ISO/IEC 11801-6

INFORMATION TECHNOLOGY – GENERIC CABLING FOR CUSTOMER PREMISES

Part 6: Distributed building services

CORRIGENDUM 1

Figure 1 – Relationships between the generic cabling documents produced by ISO/IEC JTC 1/SC 25

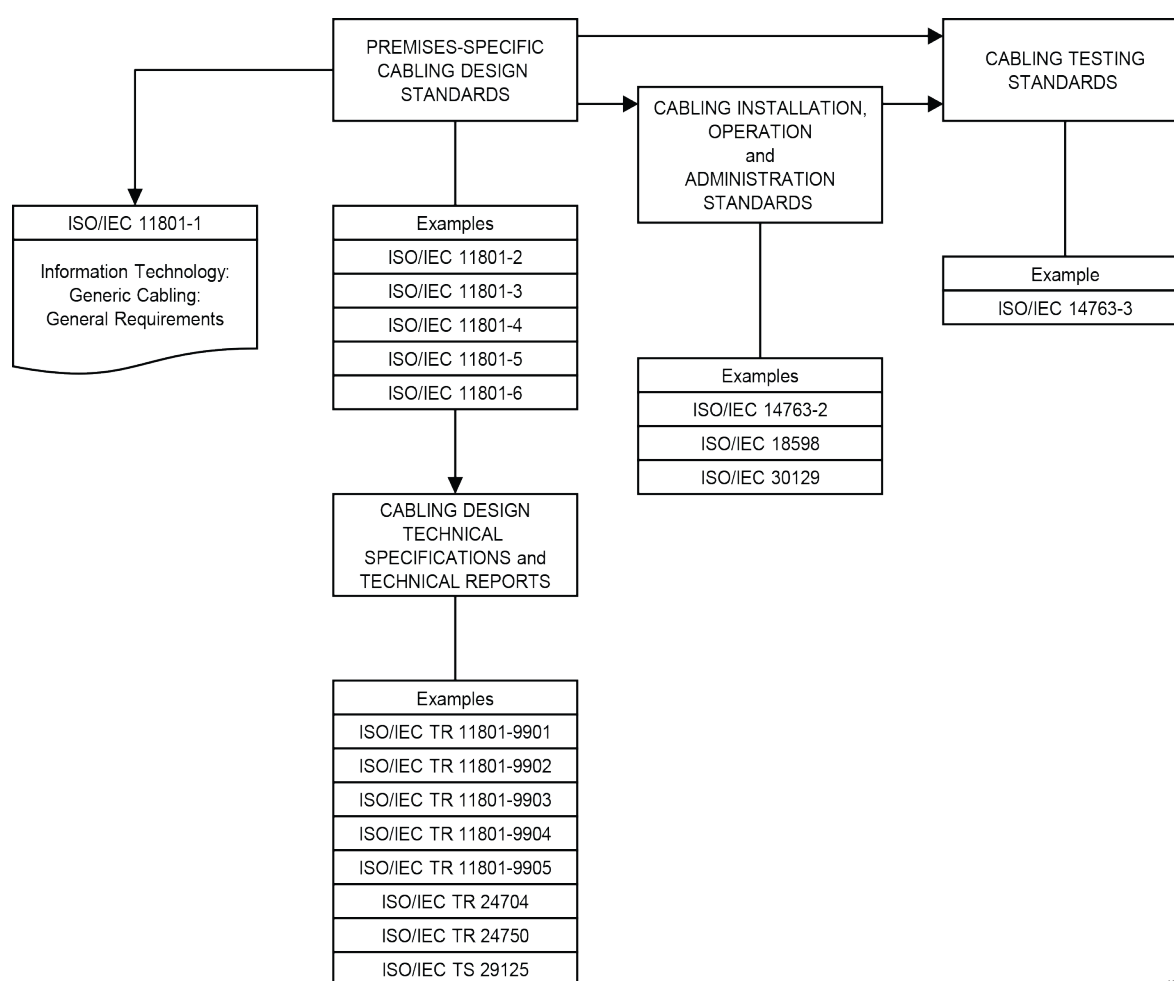
Replace the figure graphic with the following new figure graphic:

Figure 11 – Example of a Type A generic cabling system with combined BD and SD

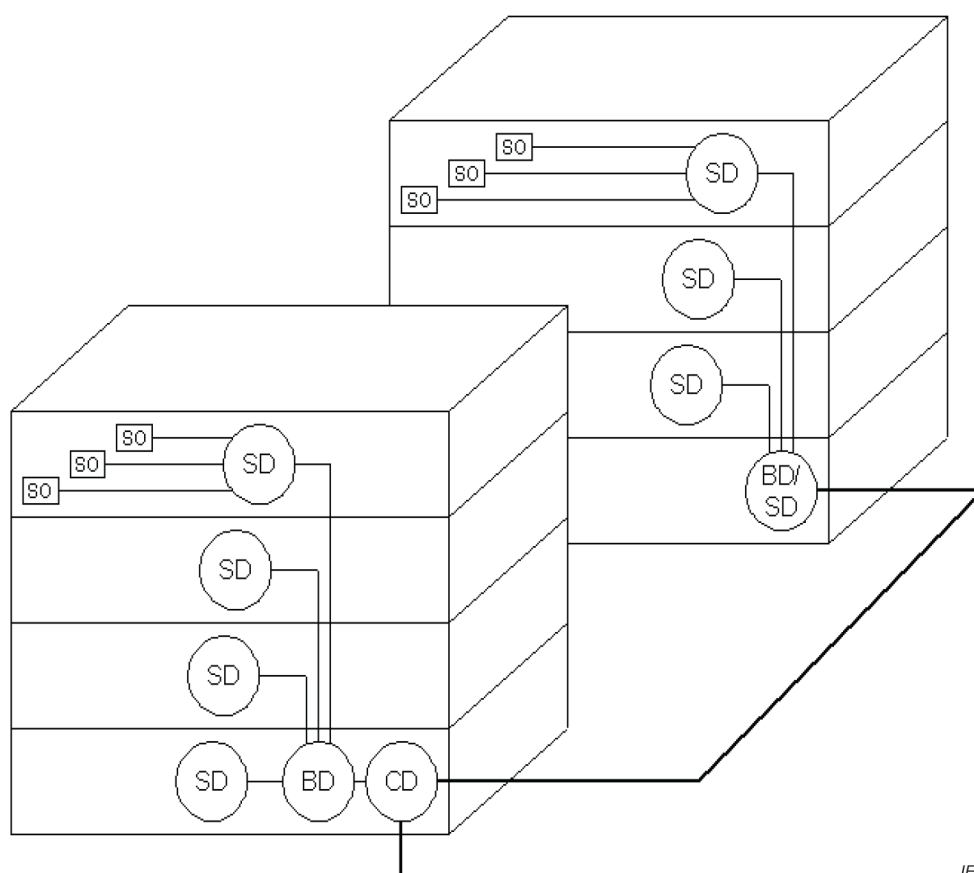
Replace the figure graphic with the following new figure graphic:
